188 South Champlain Street
Burlington, Vermont 05401

Design Advisory Board
Revised Plan - Secondary Review

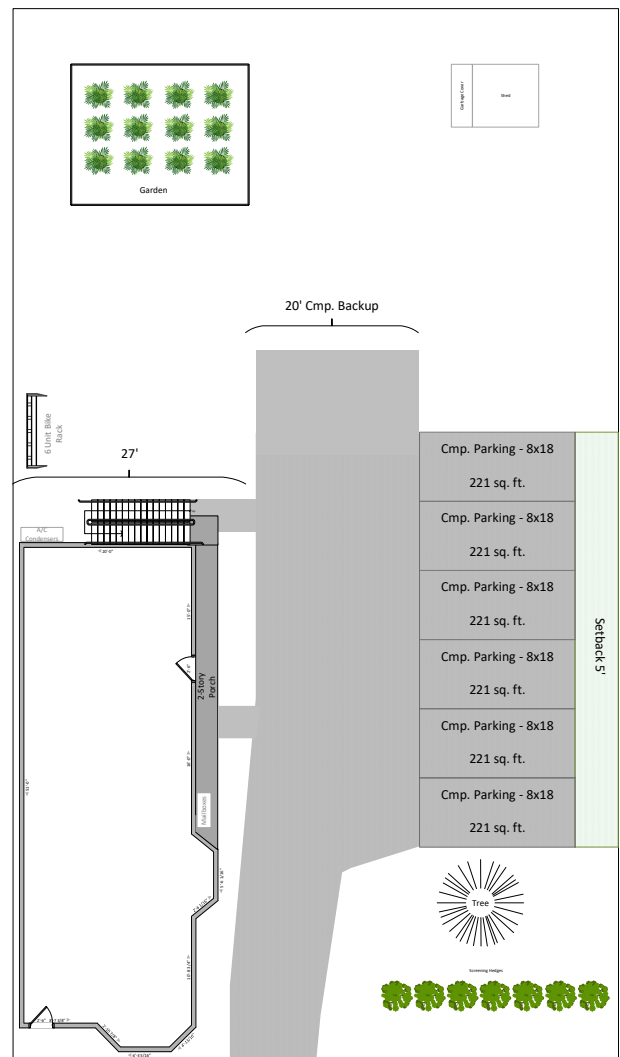
Board recommendations with respect to site plan:

- Revised site plan with reduced parking per the waiver request

The applicant has requested a waiver for a minimum of 50% parking, which at most would be 6 parking spots. The applicant contracted with Jack Milbank, Civil Engineering Associates to perform the required survey and produce the various iterations of the site plan that have been required for permitting. The version submitted along with this revised plan includes the following, as previously identified in the staff report:

- Depiction of 6 compact parking spaces
- Placement of HVAC mechanicals (in this case wall-mounted mini-split condensers)
- Placement of mailboxes
- Placement of trash bin enclosure
- Screening of parking area

Not depicted on the site plan but included in the applicant's plan is to provide secure bicycle parking near the rear of the house on the north side just east of the mechanicals.

The drawing on the right depicts these elements.

The actual engineering site plan does not depict the bike rack, garden, or snow storage as per best practices however they are depicted in the rendering to the right of this text for clarity.

2.4.1 Parking related considerations

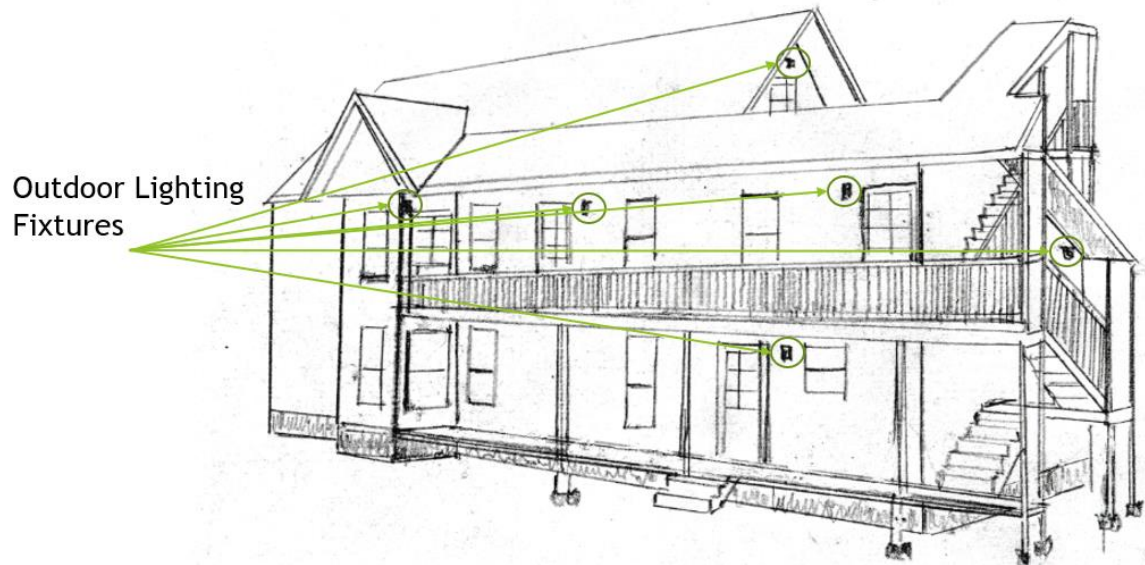
The staff report identified several considerations regarding parking. During the May 26th review, the Board stated full support for the 6-compact space waiver pending an updated site plan. The following items are covered within the site plan to address the considerations of the Board:

- Reduction of the parking area to six spaces and meeting all the requirements related to parking:
 - Setback from property boundary of 5'
 - Minimum of 20' back-up space requirement
 - Screening of the parking by both the existing large tree and the addition of a hedge row that would block its visibility from So. Champlain St.
 - A pathway to the tenant stairs is depicted on the updated site plan on the northeast side of the parking area
- Screening hedgerow is proposed to be Green Mountain Boxwood or Common Juniper

2.4.7 Windows and doors specifications and compliance

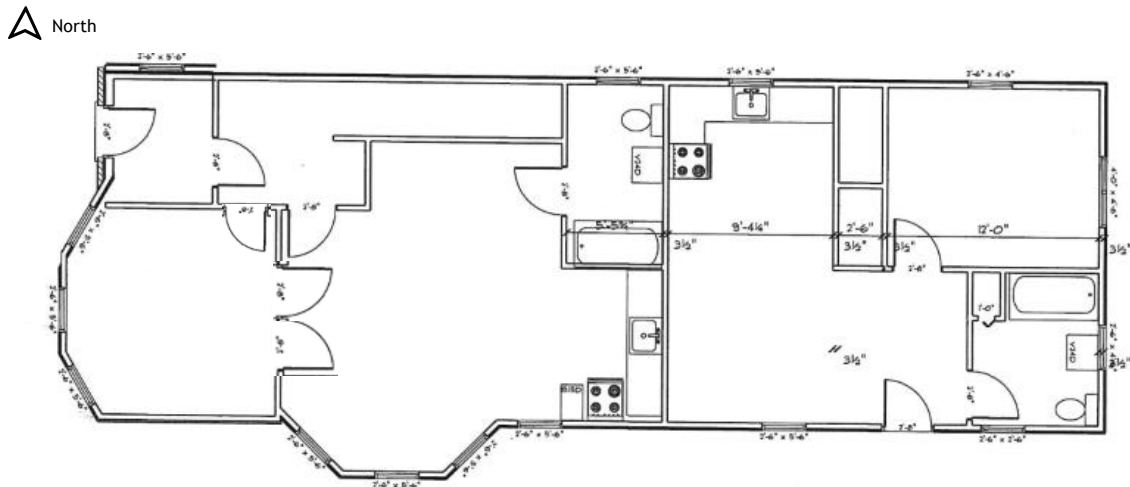
Specifically, it has been verified that the windows do comply with the following requirements, which was a concern by the Board during the May 26th review:

Artisan Builders has provided specification sheets for the proposed products, and those should be referenced directly.

All doors and windows will comply with the requirements as identified by the Board.

- Have a strong meeting rail factory adhered on the exterior of the sash to visually replicate the original double hung window when closed
- Solid wood core
